CORPUS CHRISTI REGIONAL TRANSPORTATION AUTHORITY

ADDENDUM NO. 1

INVITATION FOR BIDS
FOR
BRASS FITTINGS & HYDRAULIC HOSES

IFB NO.: 2017-SP-09 **Date Issued: May 10, 2017**

NYLON AIR BRAKE TUBING

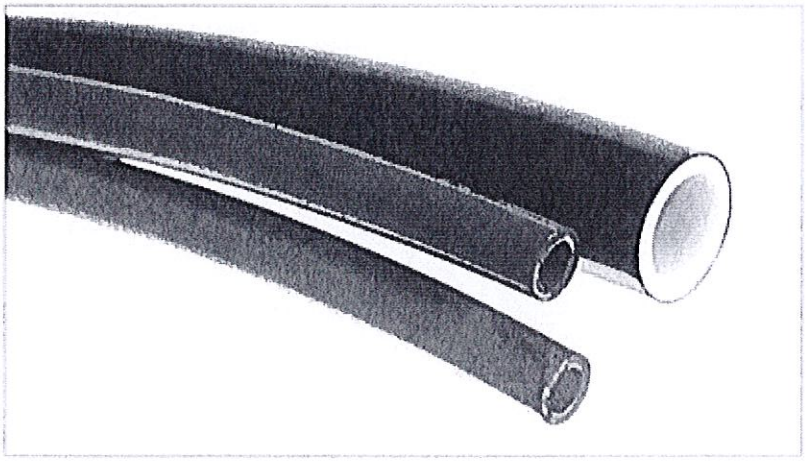
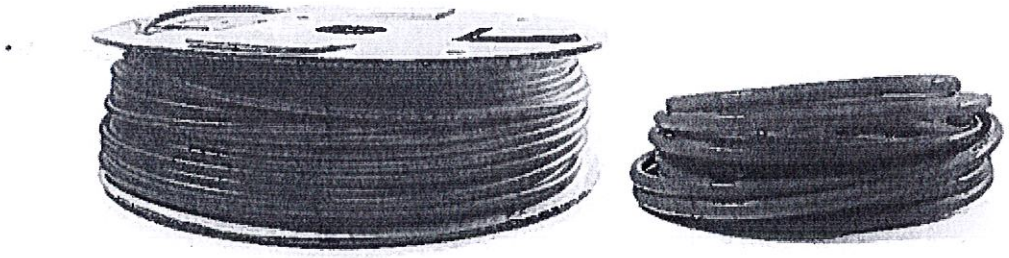
Request: Will CCRTA approve Tramec Sloan as an equal on the DOT Airbrake Tubing? Tramec Sloan provides private labeled tubing from Aeroquip (Eaton/Synflex) www.tramecsloan.com

Does comply with DOT & FMVSS 571.106 standards
